Title: Advisory Committee on Reactor Safeguards
 Northwest Medical Isotopes Subcommittee

Date: Thursday, September 21, 2017

NORTHWEST MEDICAL ISOTOPES SUBCOMMITTEE

Transient Population Distribution - 2020
Population estimates are labeled in the distance directional segments

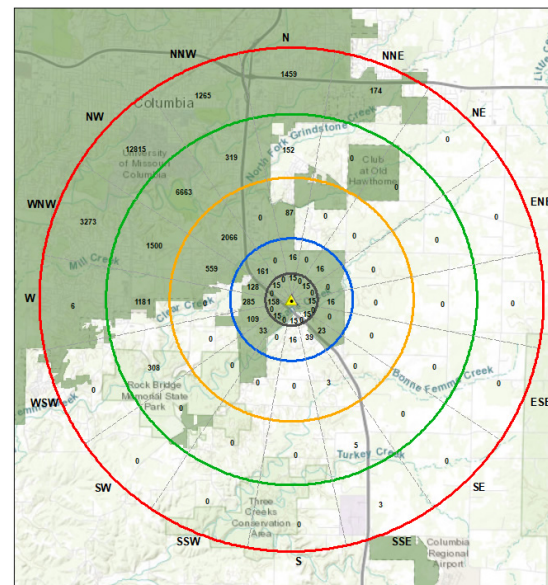
6 On Page 2, on transient population, we did
7 update that. We have gone through, and unfortunately,
8 the university didn't have a good idea on how they
9 planned, on what the transient population growth was
10 going to be, so we did work with them verbally. And
11 so we did add that to that. And so we just wanted you
12 to know that that has been added.
